1st Read Manual Language for Hybrids Phase 1a – Manual 14D and Manual 10

PJM Operating Committee
July 14, 2022

Manual 10: Pre-Scheduling Operations, Revision XX
Manual 14-D: Generator Operational Requirements Revisions, Revision XX

Exhibit 15: Example of inverter-based AC-coupled open-loop Hybrid Resource with 100 MW solar and 40 MW battery.

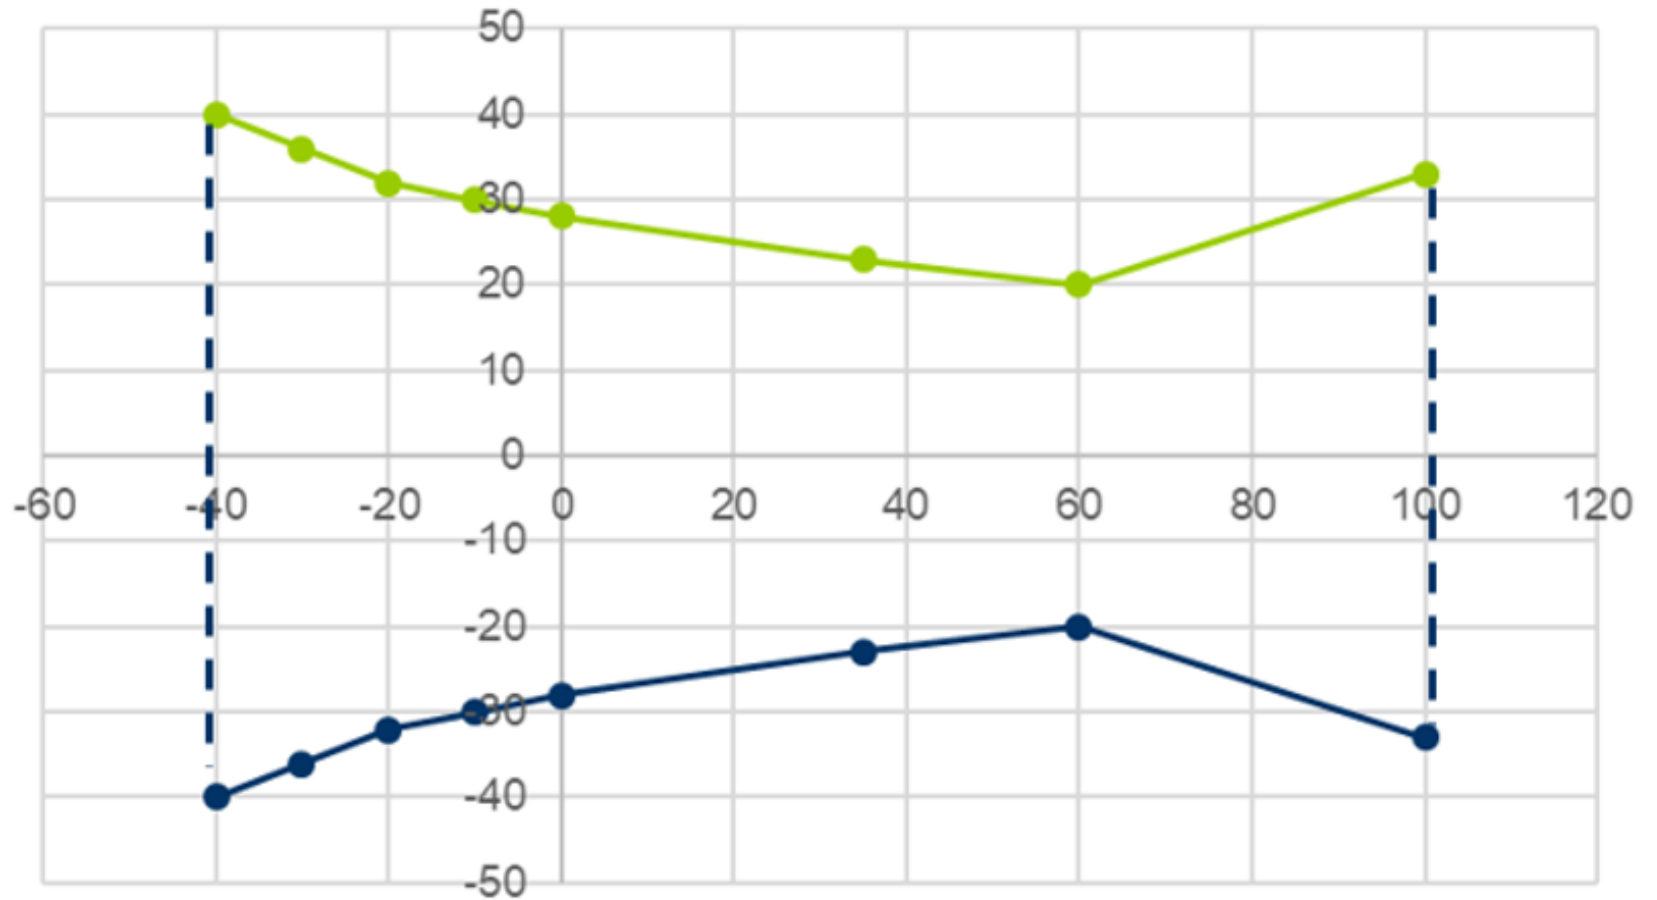
An AC-coupled Hybrid Resource has two (sets of) electrical machines (i.e., inverters), and so shows a D-curve that reflects conservative conditions.

In particular, for the solar to feed the battery, both the solar inverters and the battery inverters need to do an AC power conversion. This leaves less inverter capability available for reactive.

Figure 16: Example of inverter-based DC-coupled open-loop solar-storage Hybrid Resource with 100 MW solar and 100 MW battery.

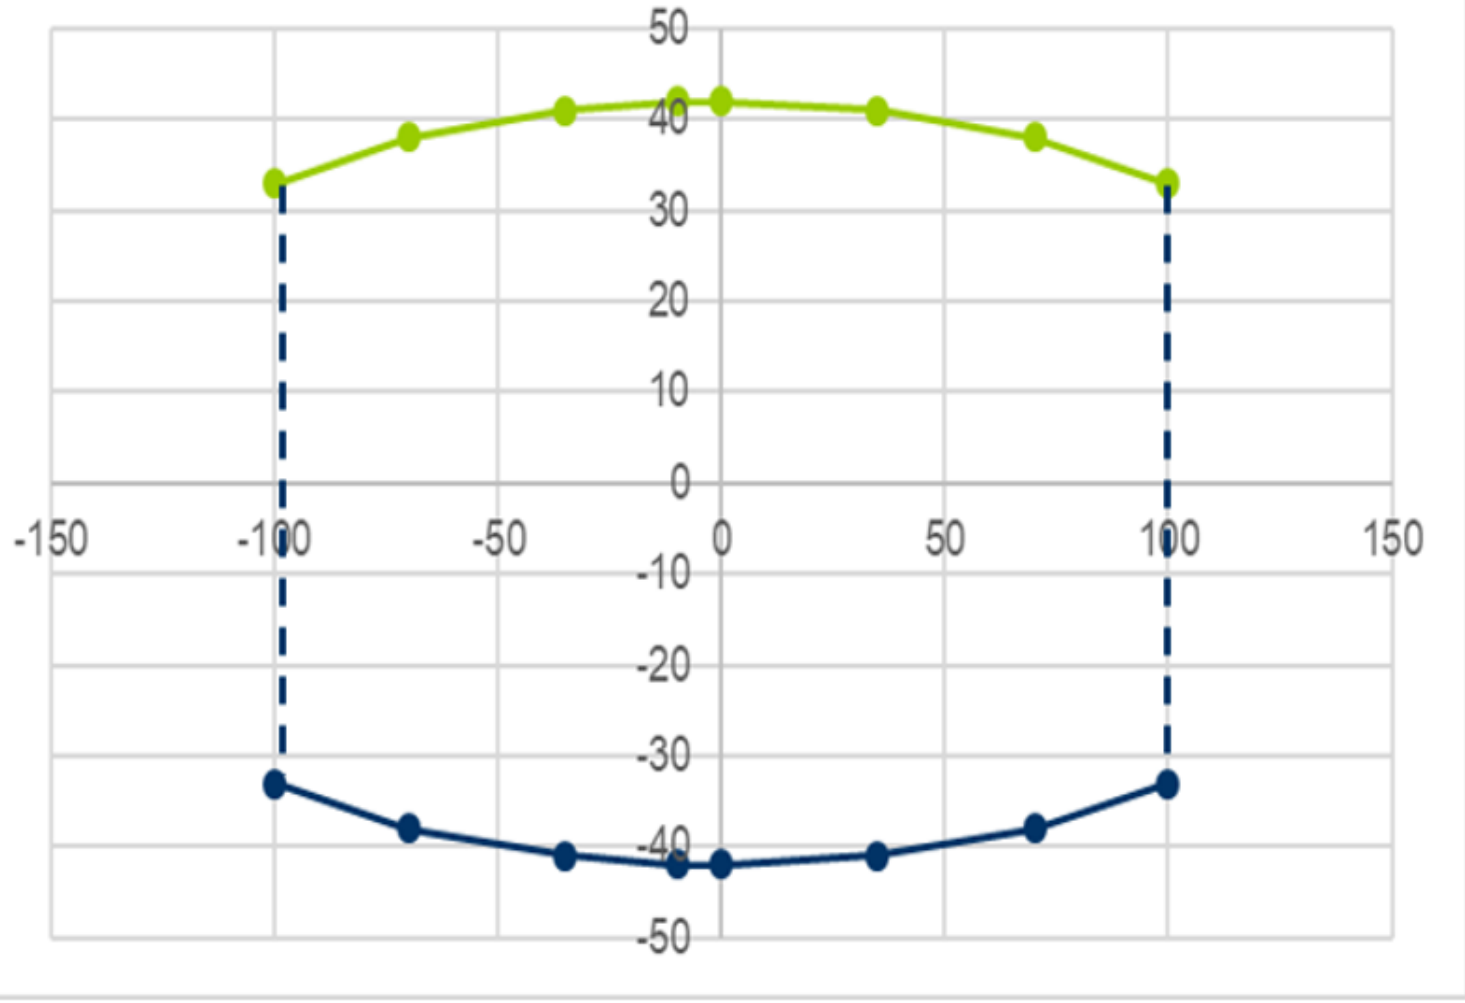
A DC-coupled Hybrid Resource has a single (set) of electrical machines (i.e., inverters), and so shows a more typical D-curve.

In particular: the solar would feed the battery directly, without needing AC power conversion. This leaves more inverter capability available for reactive.
